Applicant: Kraus-Anderson (applicant and owner)

Location: 9728 Lyndale Avenue S.

Request: 1) Preliminary development plans for a partial redevelopment at the Clover Center shopping center with future retail and mixed use development phases.  
2) Final development plans for a partial redevelopment of Clover Center to accommodate an approximately 24,000 square foot grocery store and reconstructed parking lot.

Case PL2021-191

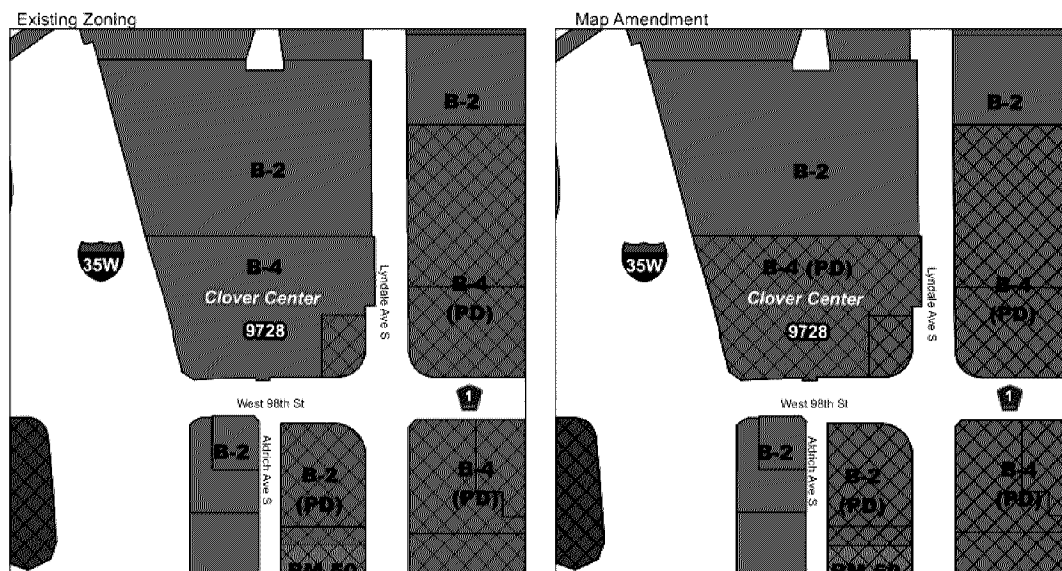
An element of the planned development process is to establish a Preliminary Development Plan (PDP), which details future development phases for Clover Center. The proposed PDP depicts a road splitting the existing building in two, which is ultimately intended to connect with Aldrich Avenue to the north. Other phases include future retail development and a high-density mixed use building along Lyndale Avenue S.

The future road connection and development phases would help implement the vision established in the Lyndale Retrofit Plan and 98<sup>th</sup> Street Station Area Plan, which were recently adopted by the City Council. Both plans envision greater development density near, and improved access to, the Orange Line Bus Rapid Transit (BRT) Station. In particular, the high-density mixed-use building located close to the street would enclose and bring activity to the street. The two future retail buildings accomplish some design expectations by locating the buildings along the street and incorporating outdoor seating spaces. Overall, staff believes the corner could support more

development intensity. At a minimum the future buildings must meet floor area and setback standards established in City Code.

2. Prior to Permit Grading, Drainage, Utility and Erosion Control plans must be approved by the City Engineer.
3. Prior to Permit Final development plans must be consistent with the preliminary development plan. Future development phases in the preliminary development plan must meet building floor area and setback requirements in the B-4 Neighborhood Commercial Zoning District.
